PRO SPEX RESIDENTIAL FRAMING INSPECTION

15503 Sample Report Rd
LAUREL MD 20707

JULY 10, 2018

2.3.1 WALLS (Structural)1

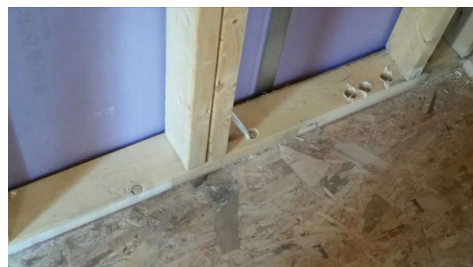
The load bearing wall does not provide adequate support for the load above. Recommend contractor review approved construction drawings and correct as needed.

2.4.1 WALLS (Non Structural)

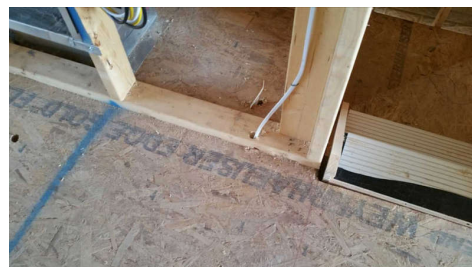
NAIL PLATE PROTECTION

Wall stud cut by plumbing and electrical contractor needs metal plates to protect pipes and wires in many locations. This is required when the edge of the bore or hole is less than 1 1/4 from the edge of the framing member.

2.5.1 FLOORS (Structural)

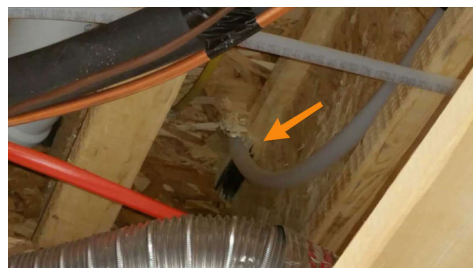
DRILLED TOP FLANGE

The floor structure has been compromised in 4 locations. The top and bottom of engineered floor joists cannot be modified in any way. These joists must be evaluated by a licensed structural engineer. Adequate documentation of the engineers findings must be provided for each joist.

2.7.1 FLOORS (Structural) 3

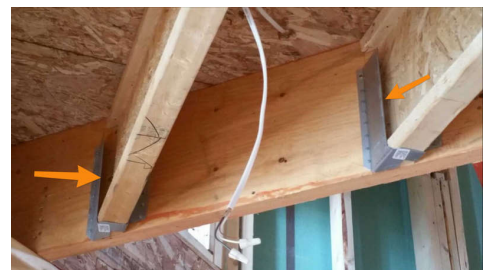
MISSING WEB STIFFENER

When joist hanger does not extend to the top flange of an engineering wood I-beam web stiffeners are required

3.1.1 Cooling System

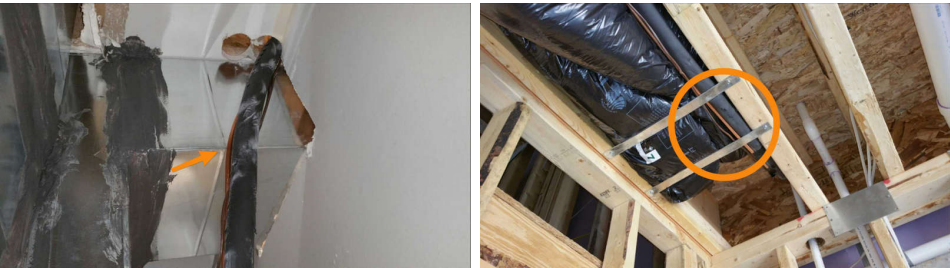
COPPER/ALUM CONTACT

Copper and aluminum when in direct contact can result in degradation of the metals, a process called galvanic reaction. Because of this, copper and aluminum should not make direct contact.
